BOULDER
COLORADO
WASTEWATER TREATMENT FACILITIES
FINAL ENVIRONMENTAL IMPACT STATEMENT

NOVEMBER 1978

U.S. ENVIRONMENTAL
PROTECTION AGENCY
REGION VIII

VIII COMMENTS ON THE DRAFT ENVIRONMENTAL IMPACT STATEMENT AND RESPONSES 147
- Public Hearing 147
- Letters of Comment 149

FIGURE 2
BOULDER CREEK PROJECT AREA

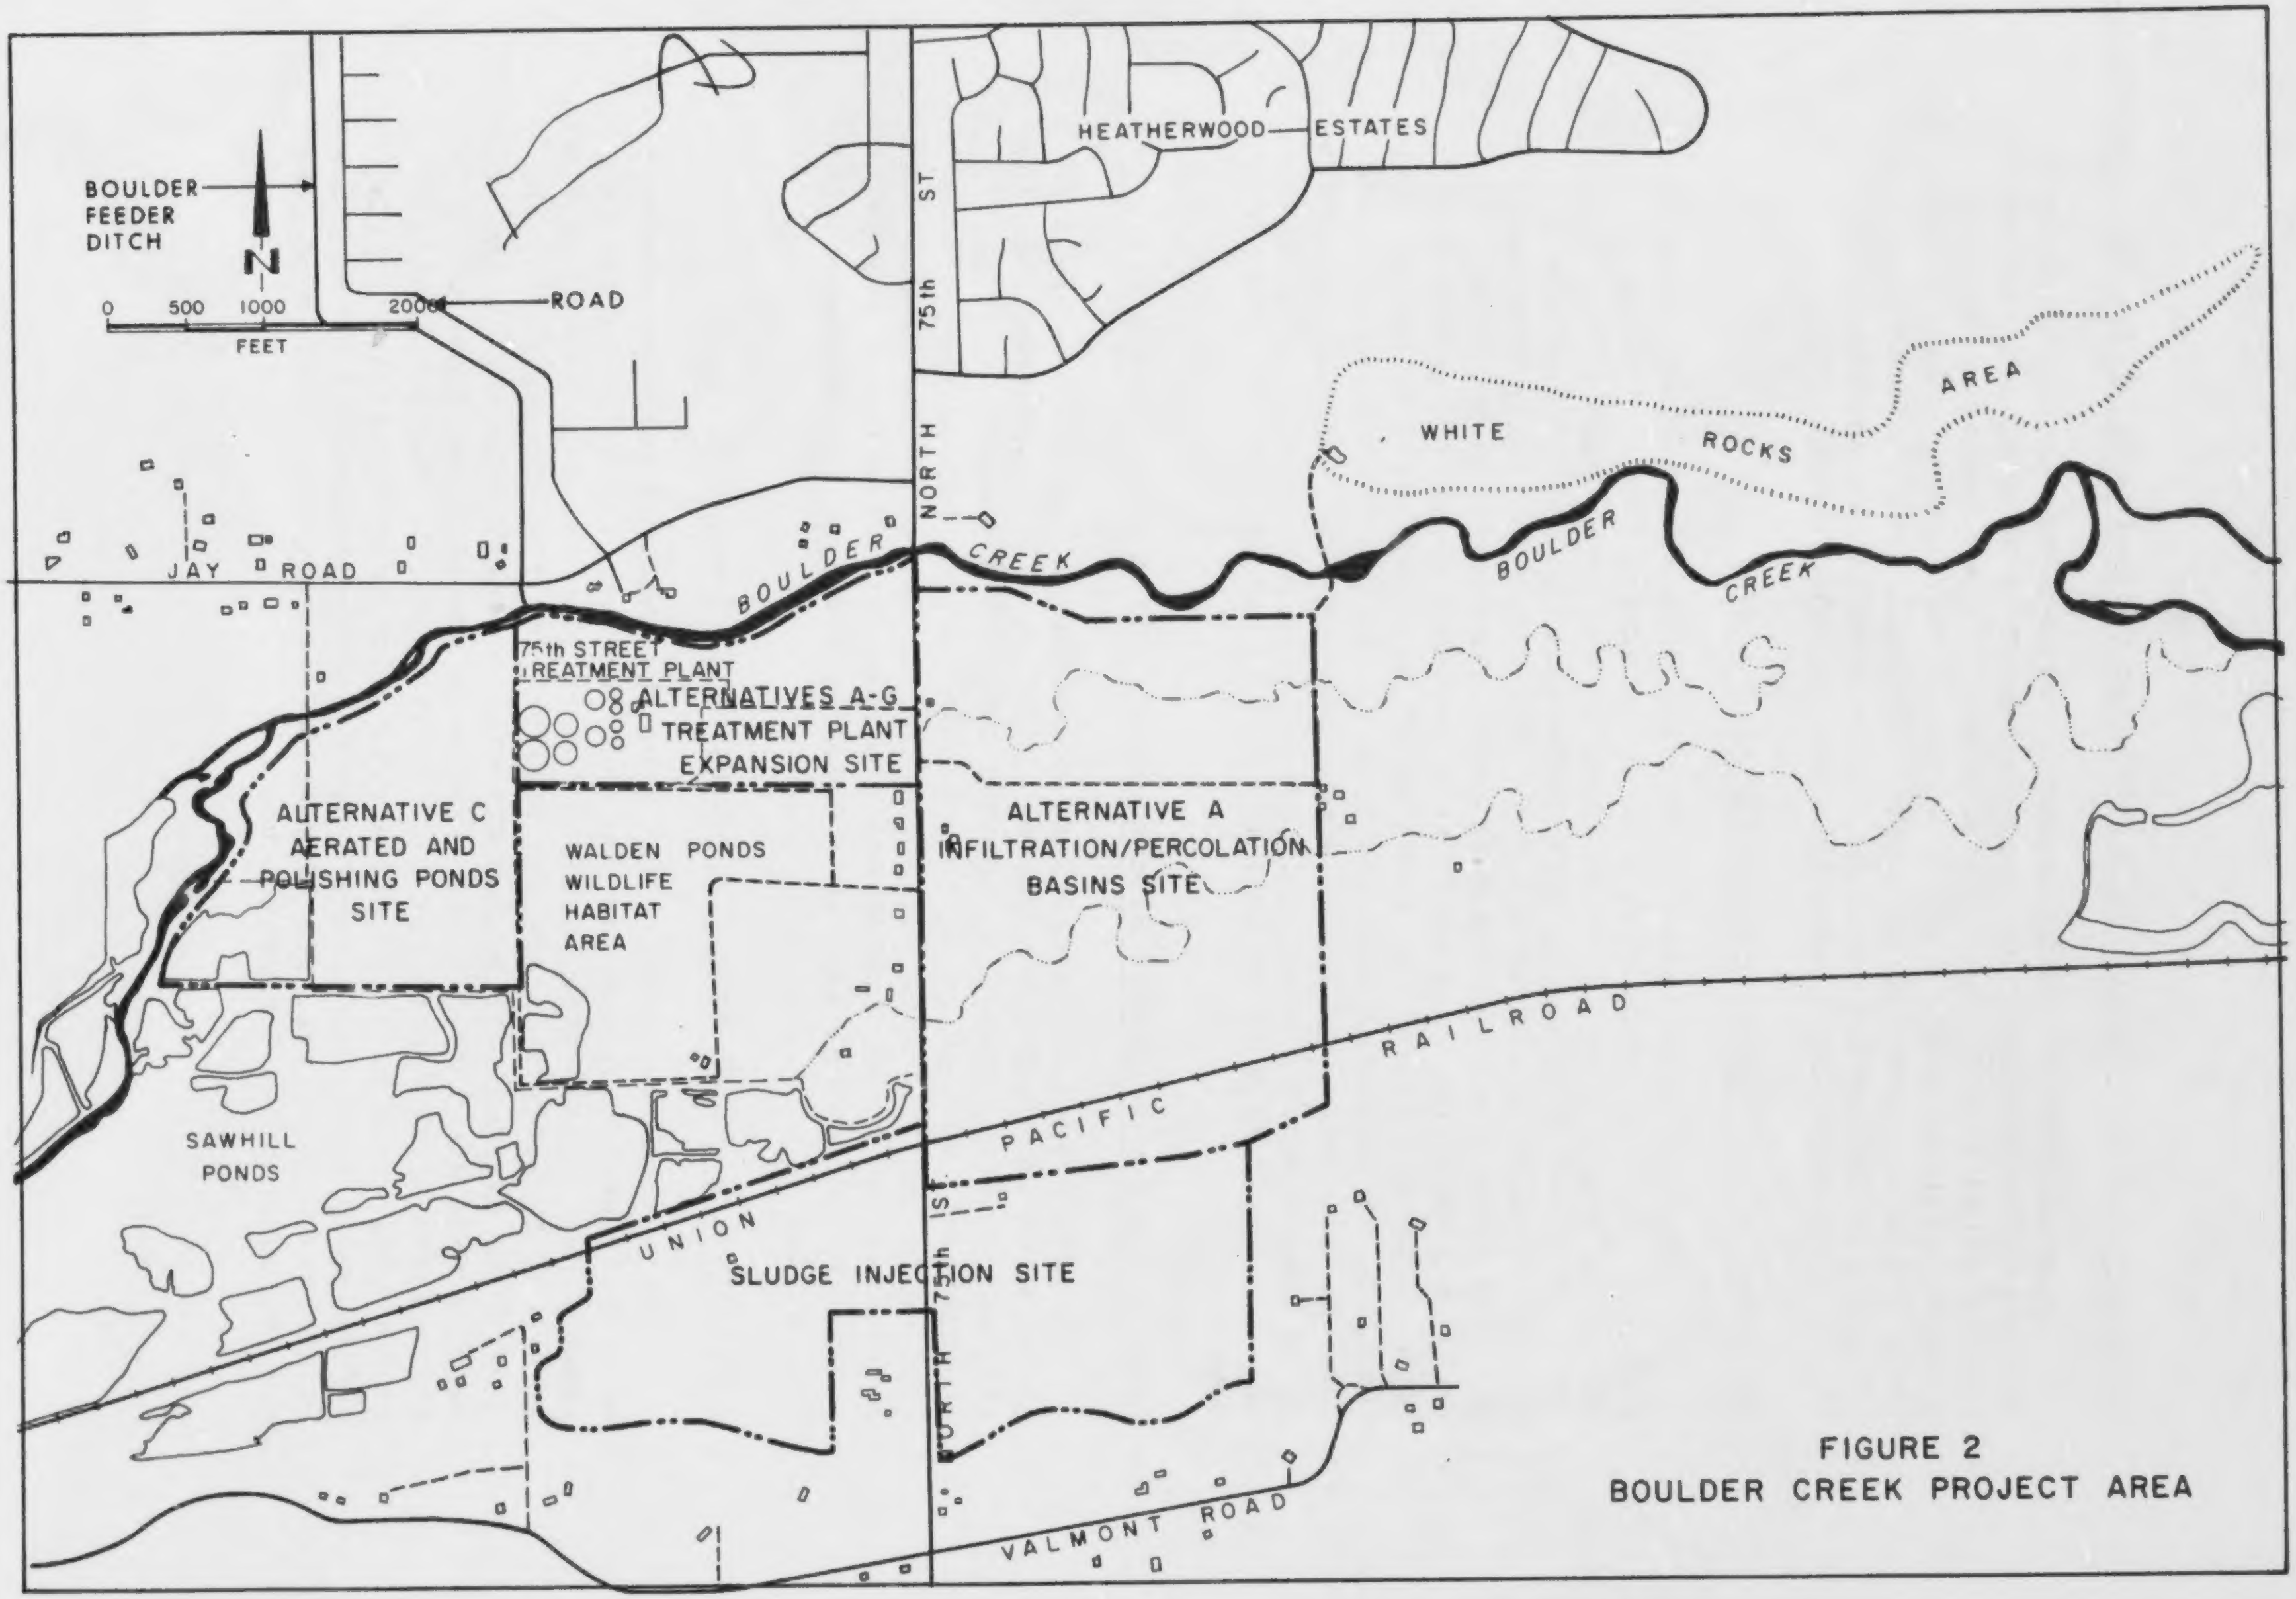
7 Figure 2, base map (in green) used throughout document, is very misleading in including a selected few residences and omitting many others - especially those in or downstream of the proposed Alt. A. and Sludge Injection (hereafter abbreviated S.I.) sites. I note particularly the house on Weiser farm immediately E of the Alt. A. site, Manchester, Fell and others due ~~S~~ East of S.I. site, homes S of Jay road and close to Alt. C., and fairly built-up Celebrity Homes area N of Jay Rd. If correction of this omission is wastefully expensive, I would hope that some textual reference to it could be made, and perhaps one correct map. ❶

1. The base map in Figure 2 and subsequent figures have been revised to include all houses around all of the alternative treatment and sludge injection sites.

FIGURE 11
BIOTIC COMMUNITIES AND
SENSITIVE ECOLOGICAL AREAS

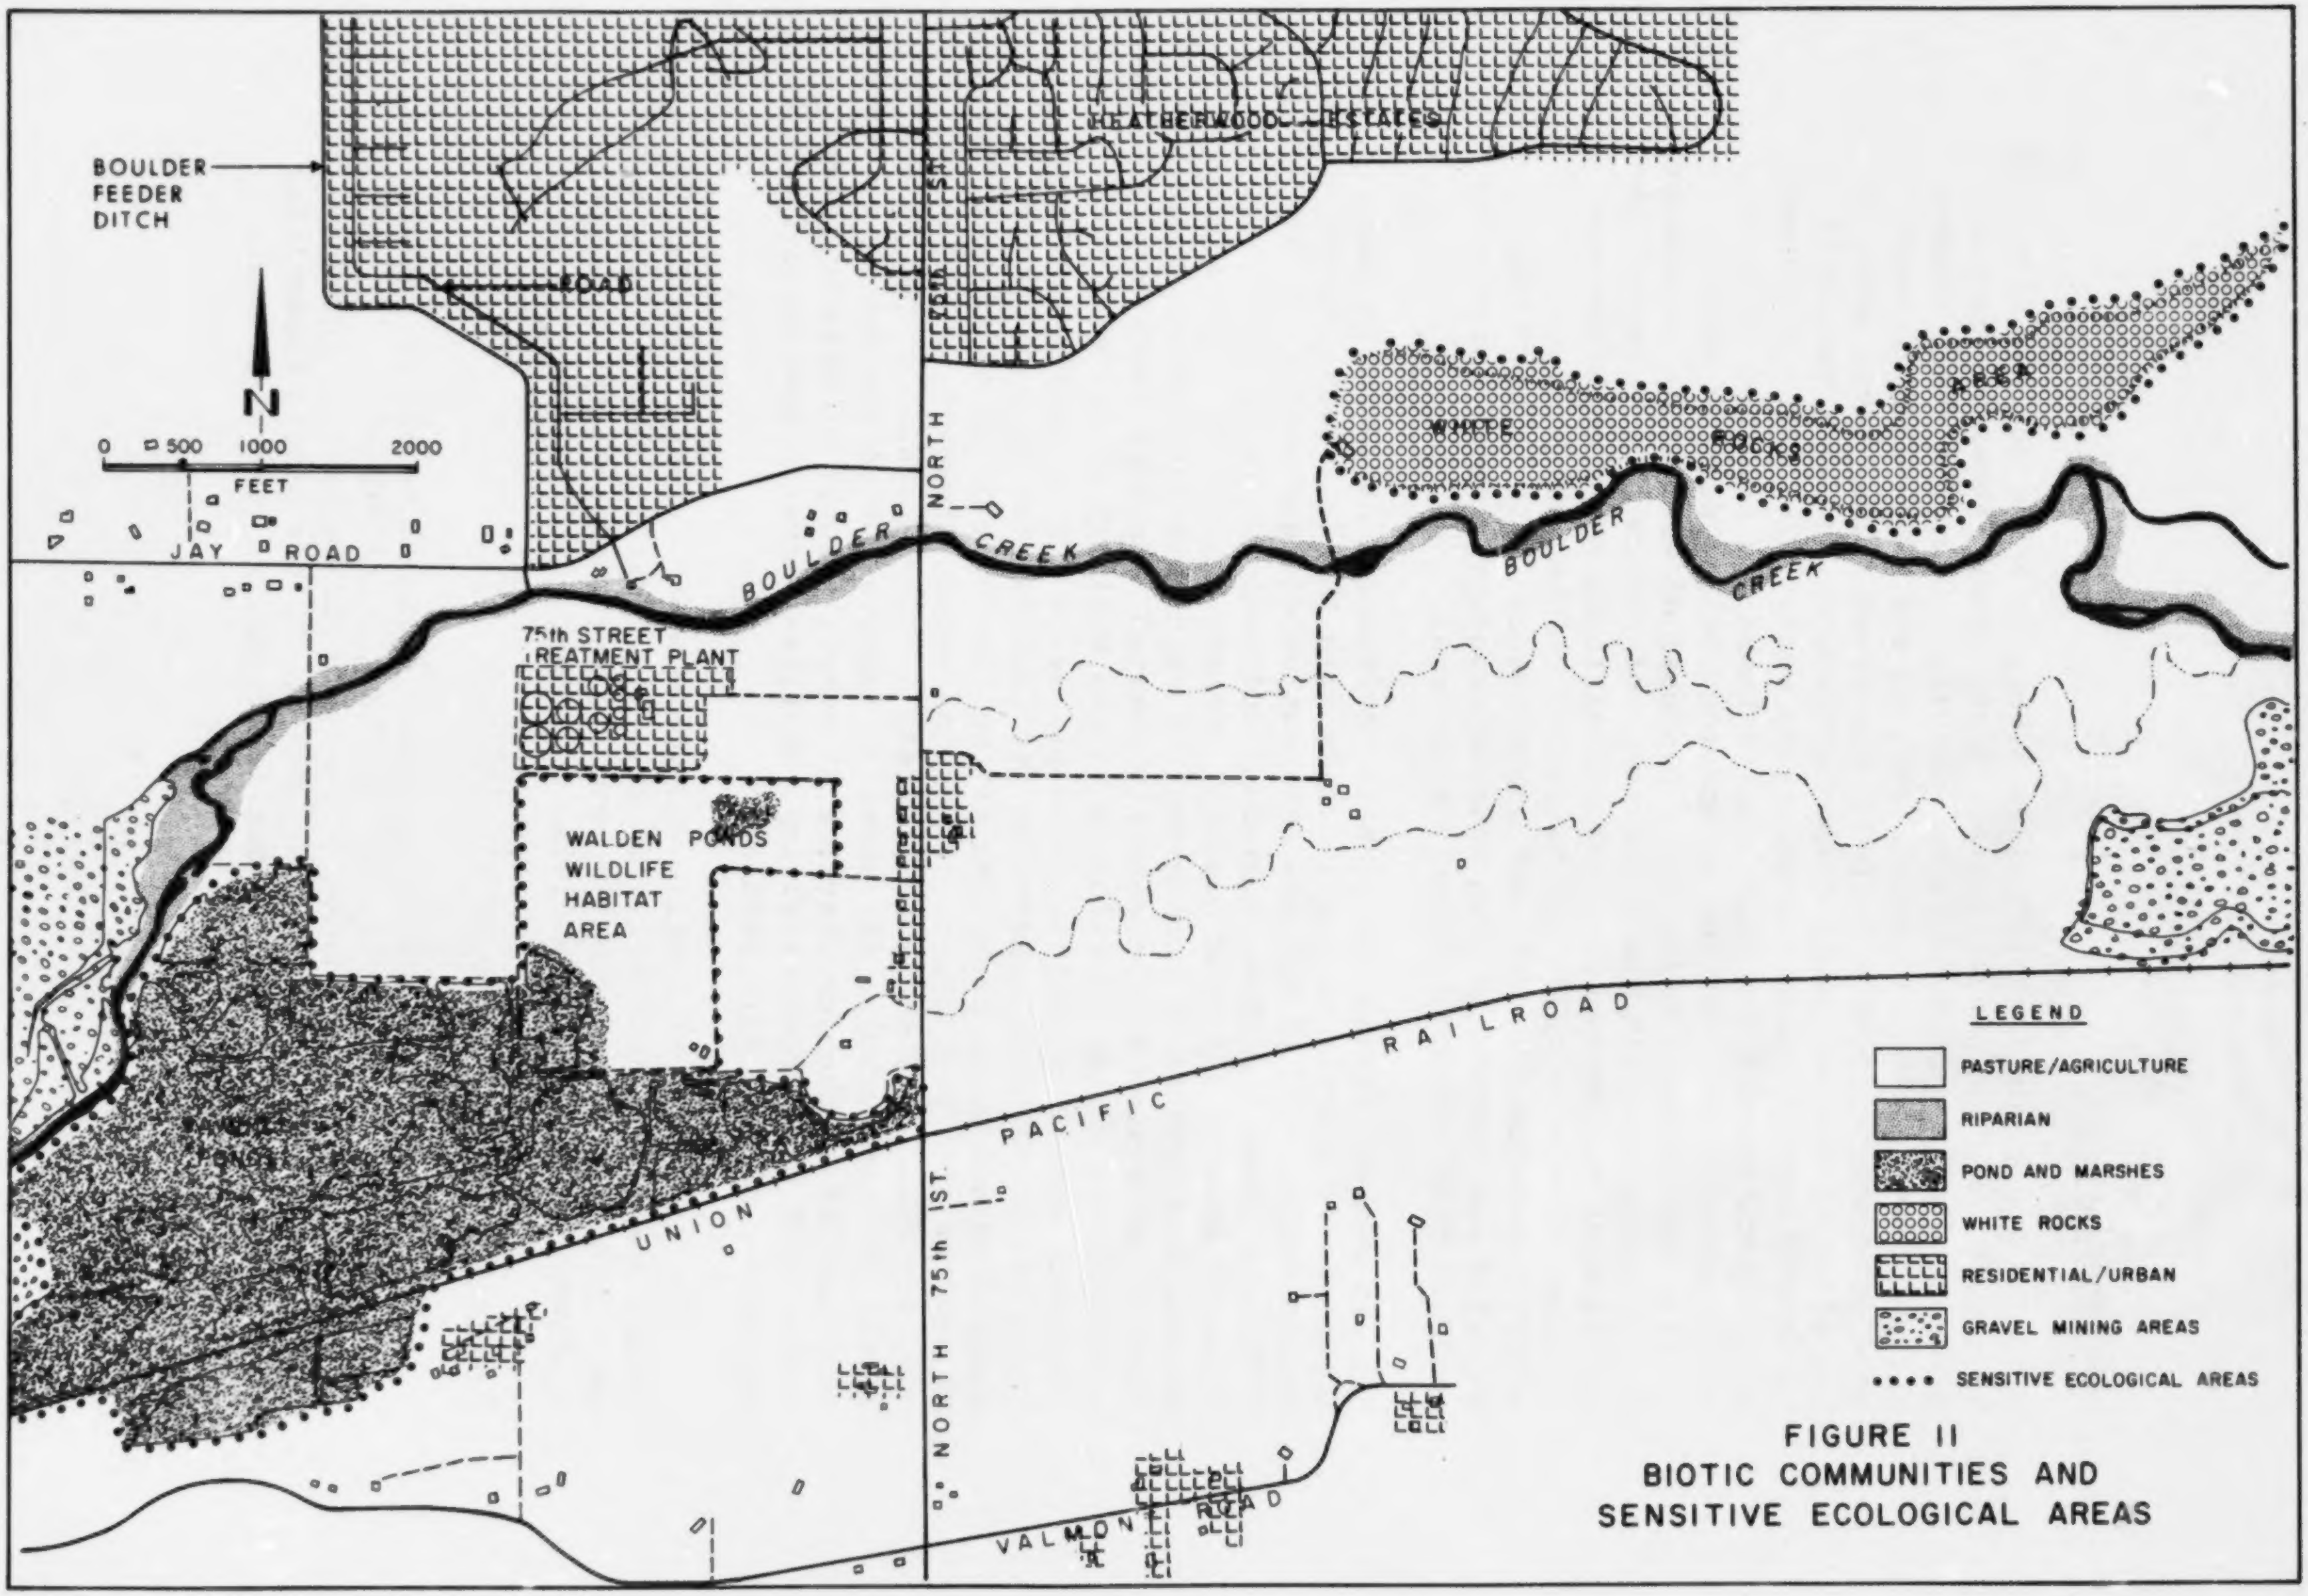
46 Figure 11 has several errors. First, as noted above, the WRNA extends well into the floodplain and includes that reach of Boulder Creek to which it is adjacent. The "sensitive ecological area" designation should follow this definition. Second, there is a swath extending NW of the actual White Rocks to the Heatherwood Area which seem unjustified by any definition. Third, Gravel Mining Areas are inadequately shown, with County pits W&S of Walden Habitat omitted, and extent of Flatiron operation not shown (entire area is now surrounded by dewatering trench, to just E of my property line which is Center line of Sec. 18.) Fourth, residential/urban should extend farther W along both sides of Jay Road, should include Fell and adjacent homesteads N of Valmont Rd., Nowell house, Manchester, and residences S of Jay Rd. and W of 75th. These omissions clearly arise from the misleading base map.
